RHO/RMS/EP
OPERATIONS CHANGE NOTICE

OCN No. 1590

- a. Title: "Model 1500 Loading Procedure"
- b. Chapter and Section: XIX Revision 11/16/92 Page(s) Attachment I
- c. Form No.: N/A Revision Code N/A

SK98026

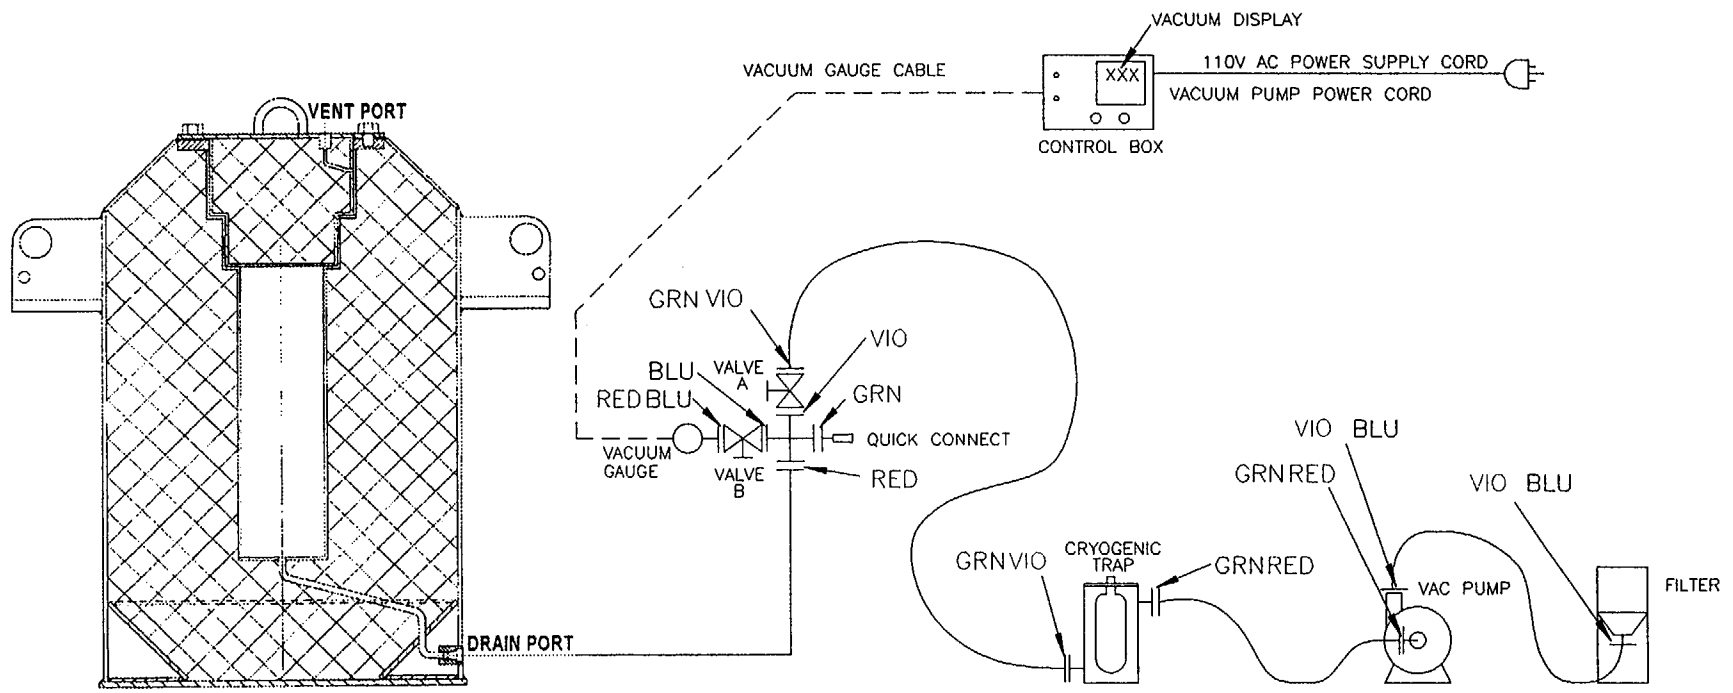
- a) Delete current 3-page Attachment I, (Vacuum Drying Procedure, Cask Cavity Drying Procedure, and Model 1500 drawing). Replace with new 2-page Attachment I (Vacuum Drying Procedure and Model 1500 drawing).
- b) First paragraph "Note"; change to read: "... (A) the cask cavity has been drained of water, (B) the drain line is unobstructed by observing the quality of the stream, (C) all lid bolts have been installed and torqued according to procedure, and (D) vent port pipe plug has been installed and tightened."
- c) Step 3, change to read: "...vacuum gauge, valve and quick disconnect as shown in the diagram."
- d) Step 10, change 15 torr to 3 torr.
- e) Step 11, change first sentence to read: "...pressure reads less than 1.0 torr for a period of no less than 30 minutes."

To add clarification to the procedure and to incorporate the requirement for a longer evacuation period below 1.0 torr.

- ***| 3. Attach color-coded tee, vacuum gauge, valve and quick disconnect as shown in the diagram.
4. Connect color-coded vacuum hoses between valve, cryogenic trap (cryogenic trap must be dry inside and lid snug), vacuum pump, and HEPA filter. See diagram.

9. Turn on vacuum pump and gradually open the valve. **CAUTION: CRYOGENIC TRAP MAY BOIL OVER.**
- ***| 10. Verify that vacuum pressure is reduced by reading the vacuum display. Typically, the vacuum pressure will stabilize at approximately 3 torr while the moisture is being drawn from the cask cavity.

- ***| 11. Continue the procedure until the vacuum pressure reads less than 1.0 torr for a period of no less than 30 minutes. Pressure must continue dropping during this period. A rise of pressure may indicate trapped moisture in the cask cavity. The cask cavity is vacuum dried once a continuous drop in pressure is obtained.
